DAMMON

June 16, 2020

For: Joan and John Ascherl
226 Hoffman Lane
Waveland, Ms 39576

Dammon Engineering was contacted to request a structural inspection of the referenced new home due to the homeowner noting rainwater build up on the raised covered rear porch and the concern of the structural attachments for it.

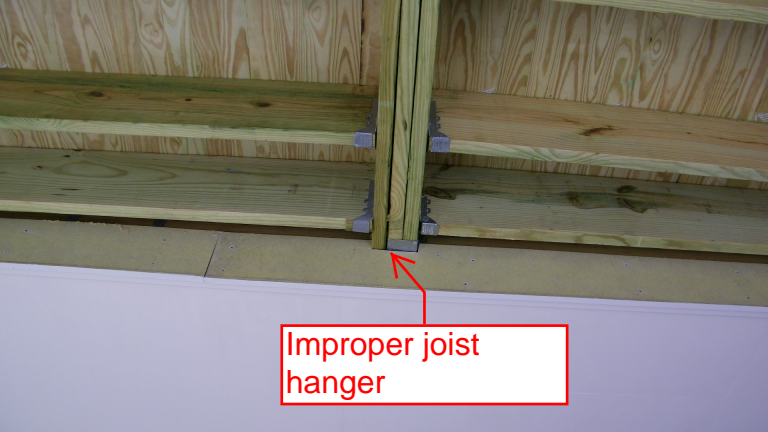
Improper joist hanger

Remove and
replace

Caulk against house

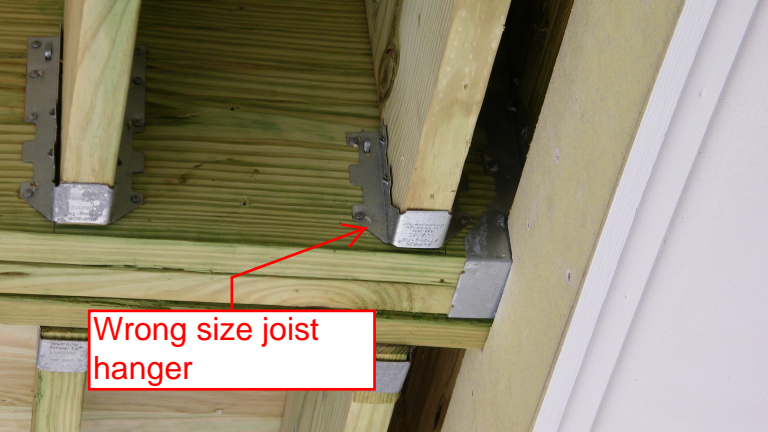
Saw cut bottom
plate

Wrong size joist hanger

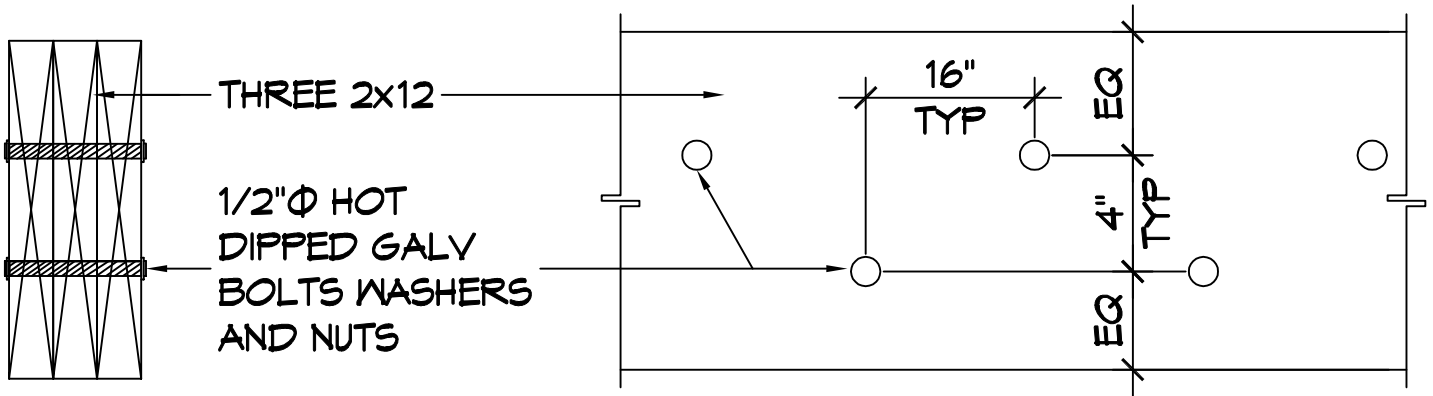
Bolt beam together
